LARAMIE COUNTY PLANNING & DEVELOPMENT DEPARTMENT

MEMORANDUM

TITLE: Review and action of a Subdivision Permit and Plat for Cheyenne Hills

Church, 2nd Filing, a replat of a portion of Lot 1, Block 1, Cheyenne Hills Church Subdivision and a portion of the N1/2, NE1/4, Section 25, T.14N.,

Attachment 9: Revised Plat – January 24, 2018

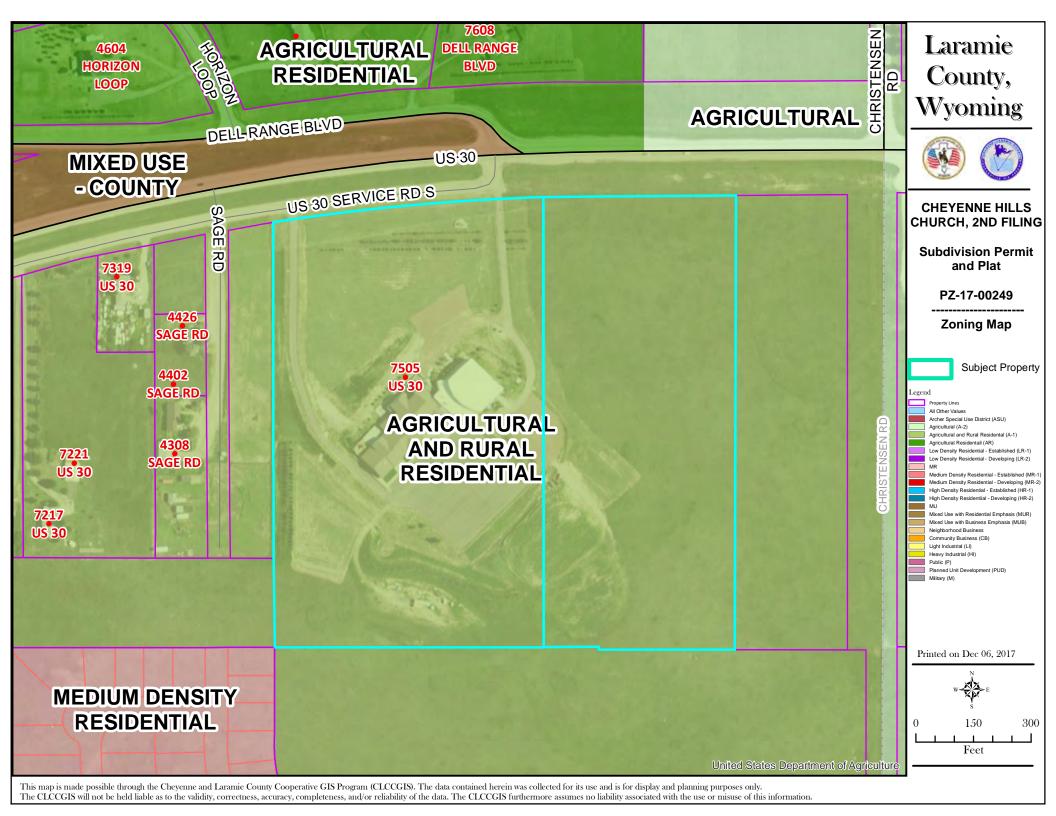
<u>County Assessor:</u> Clarice Blanton COMMENTS ATTACHED 12/11/2017 The Re-plat description should include 'Lot 1, Block 1' (of Cheyenne Hills Subdivision), and a re-plat of a portion of the North 1/2 of the Northeast 1/4 of Section 25, T14N, R66W.

- 1. Plat Note number 2 indicates that there are portions of this platted area that fall within a FEMA Special Flood Hazard Area. The applicant should verify this is correct because it does not appear there is any flood hazard area within the platted area. If the applicant does indeed determine this note is correct, then the FEMA Flood Hazard Area needs to be shown on the plat and the plat resubmitted.

- 1. Plats require the location and dimensions, with boundary ties, for all existing and proposed utility, drainage, access, or other easements be shown. The utilities easements boundary ties/dimensions shown near the center of the North boundary of the subdivision are a little difficult to read as they are overlaid amongst the easement boundary lines.

- 2. Plats require the right-of-way lines, widths and names of all streets or roads within and adjacent to the proposed subdivision/development be shown. The approximately 100 foot wide strip of land falling just south of the South boundary of the subdivision is labeled as "Saddle Ridge, 12th Filing" on the west side and "Unplatted" just below the subdivision. A division line showing the location of the 2 separate entities should be shown.

- 3. Plat layouts shall include such additional information as may be required to adequately describe proposed utility systems, street improvements and easements or reservations contemplated within the area to be subdivided. There are a number of "UTILITY EASEMENTS" shown on the plat. It is not clearly shown or noted/specified which utilities are allowed to utilize which easements. Can any utility use any easement or are there any restrictions?

4. Plats require any recorded easements or restrictions applicable to the subdivision shall be noted by reference to Register's book and page number. The County will not be involved in the enforcement of deed restriction or covenant instruments. There are number of "UTILITY EASEMENTS" shown on the plat. The plat does not identify, on the face of the plat or within the DEDICATION STATEMENT, whether these easements are all pre-existing or if some of them are being created as a result of this plat. None of the easements refer to the Register's book and page number.

Condition 2 was satisfied by submittal of a revised plat on January 24th, showing all required corrections.
